HISTORIC PRESERVATION BOARD STAFF REPORT

46 Marine Way

Meeting	File No.	Application Type
June 4, 2025	2024-133	Certificate of Appropriateness, Relocations, Variances, & Waivers

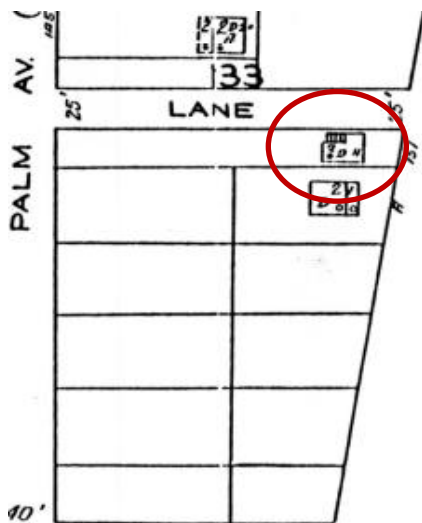
With respect to **Height**, the board expressed concern about the overall impact the size of the structure will have on the streetscape. This includes the 35' maximum height that is proposed. Although the revised proposal includes the shifting and reduction of square footage for the third floor, it is still impacting the overall streetscape. It is also important to note that most of the third story will likely not be very visible when standing in front of the property from the right-of-way. Historically, the Marina Historic District has a pattern of one to two story residences. Additionally, the revised proposal continues to require relief from the Building Height Plane (BHP) requirements, with the new addition being majority of the structure within the "no build zone".

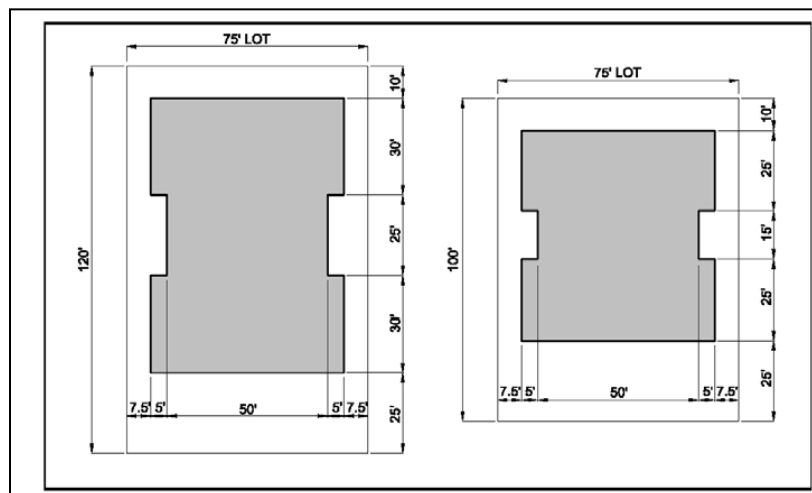
As more development occurs within historic district, it is imperative that the historic sites and the historic streetscape as a whole remain with compatible massing and size in order to maintain the historic setting of the district. The Marine Way area is known for flooding during storms and King tides and vertical elevation of the existing contributing structure will improve its resiliency to flooding. The height requirement to elevate to a minimum 9-foot finished floor elevation is now required by FEMA. However, the proposal involves elevating the existing structure to a finished floor elevation of 14 feet, 5 feet above the minimum requirement in order to accommodate a ground level garage underneath the historic residence. Thus, nearly the entire historic structure and portion of the new garage fall within the “No Build Zone” of the BHP. Also, the entirety of the third-floor rear addition and a portion of the second floor are

within the “No Build Zone”. Three-story structures do exist within the historic district, but they are limited to newer built structures, which are located further west and south of the subject property where the land is slightly higher than the subject site. It may not be possible to elevate the existing structure with a two or three-story addition to the minimum FEMA finished floor requirements without seeking a waiver to this visual compatibility standard. But the extent of the waiver would need to be studied. Should the proposal have planned for a one or two-story addition only to the rear of the site and also situated the historic residence at a 9-foot finished floor elevation, the impact upon the historic district and adjacent streetscape could be minimized. The board will need to determine if the waiver results in a special privilege and if the same waiver would be granted under similar circumstances on other property.
